Bulletin No: SB2004-14

Machine/s: Model 430

SUBJECT: Kohler muffler

Kohler muffler replacement.

Figure 1

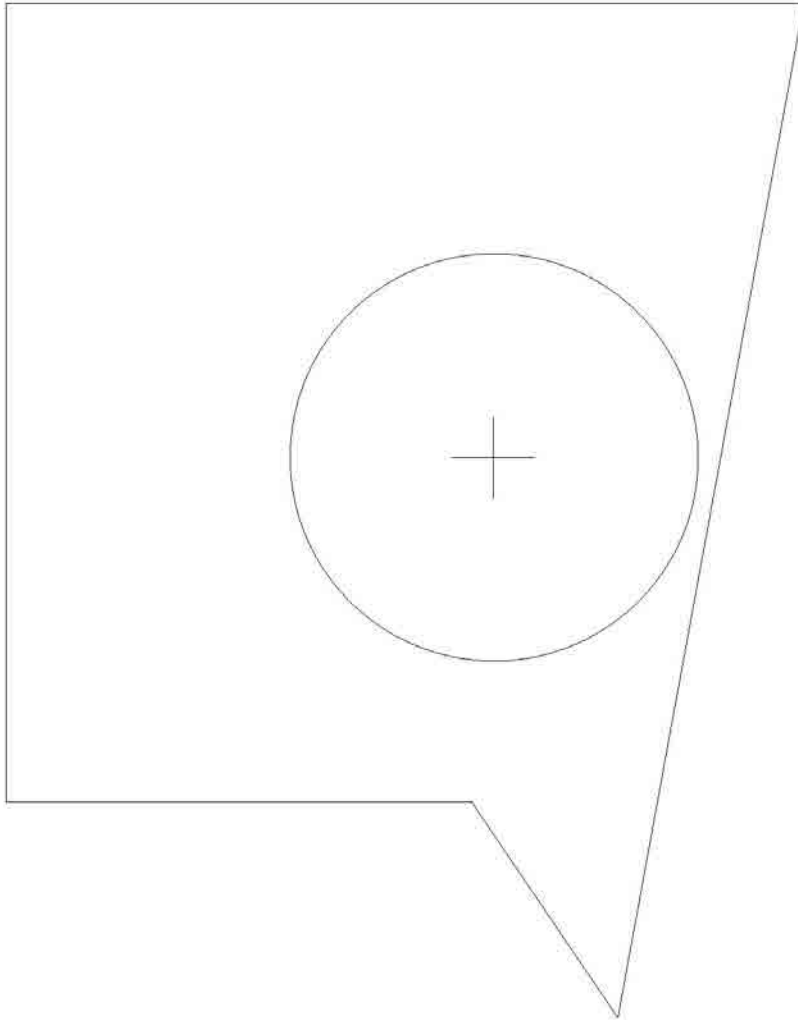
- 1) Order 4132729 muffler, 64205-013 M6-1 x 12 Bolt, 64006-01 ¼ " lock washer and 60-579.17 grille.
- 2) Order 4132729 muffler, 64205-013 M6-1 x 12 Bolt, 64006-01 ¼ " lock washer and use the template in figure 1, to add the hole in the grille for the exhaust tube.

Figure 2

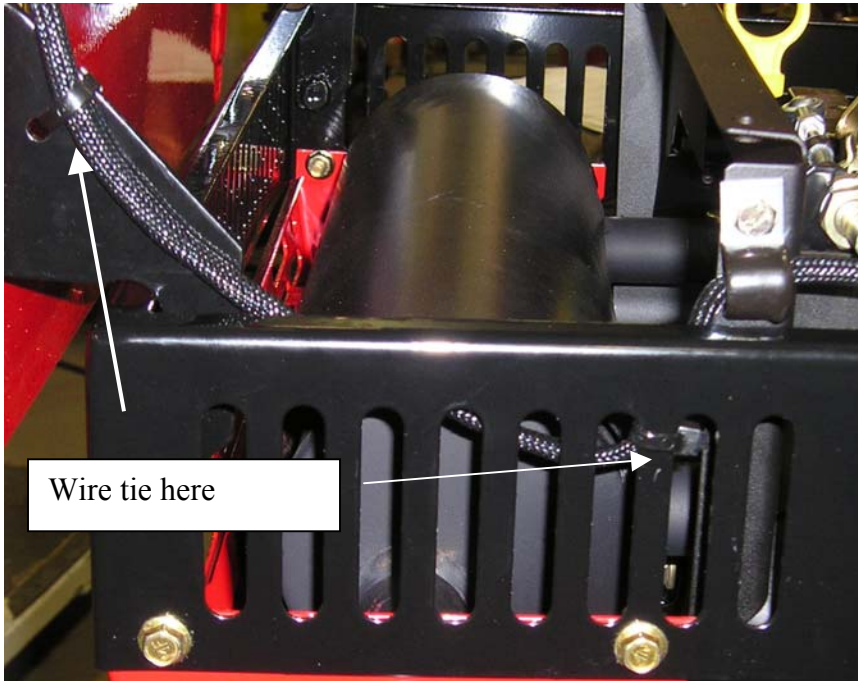
When muffler is installed route the headlight wires as the picture shows in figure 2. You will also need to use quantity of 2 wire ties to keep the headlight wiring away from the muffler.
